SEWAGE DISPOSAL SYSTEM

MARYLAND STATE DEPARTMENT OF HEALTH

Howard Pickett

PROPERTY OWNER William Frances Mitchell

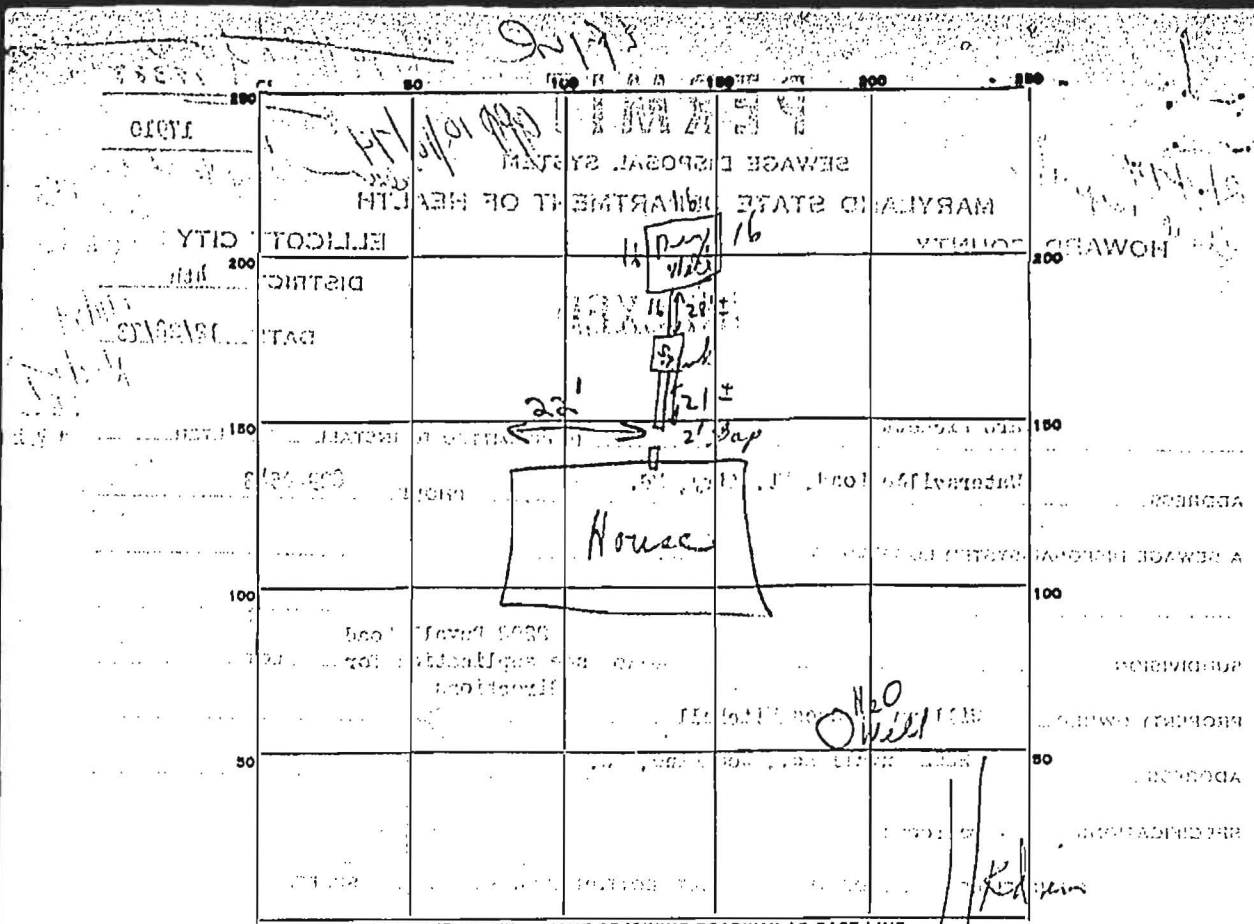
REMARKS: 2/1/74 Pipes from House not connected to pipe from Septic Tank. Hold for suspension. Help notes to call when pipe is connected from house to septic tank. CBS.

2/11/74 No changes CBS + H.Z. 10/7/74 Checked with Mrs. Mitchell she stated husband completed system and he is to write notes concerning same. H. Water rights.
